STAFF REPORT 10-09-2024 REGULAR MEETING

APPLICATION NUMBER: HDC2024-00523

ADDRESS: 1457 SEMINOLE

SCOPE: REPLACE ASBESTOS-CEMENT SHINGLE ROOFING WITH ASPHALT SHINGLES

The shingles at 1457 Seminole were laid using the "American Method" (bottom), per this drawing made available by the National Park Service, from 1913. This is an attempt to mimic the rectangular and orderly expression of slate.

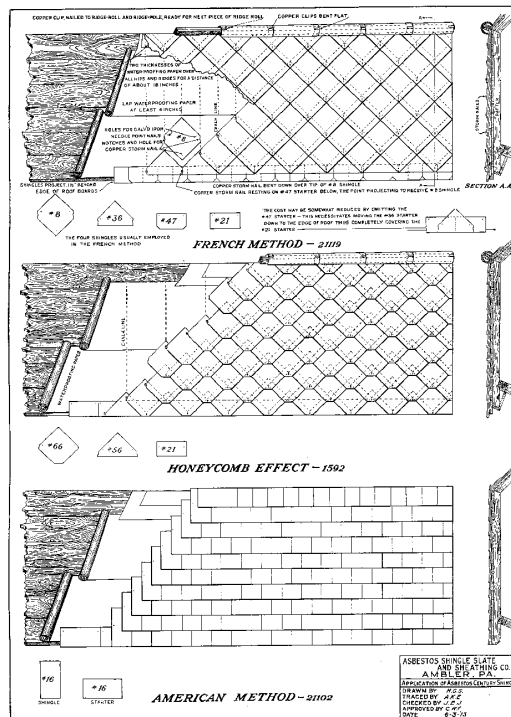
- The existing shingles have a clear manufactured “texturing” that appears to imitate wood, which is mentioned in the NPS historical information as a common feature. The overall expression, however, tends towards the rectangular order of a slate roof. A 1991 surveyor’s report in HDC files describes the roofing as “composition shingles.” All HDC records and photographs of the property show these same shingles in place dating back to 1971.
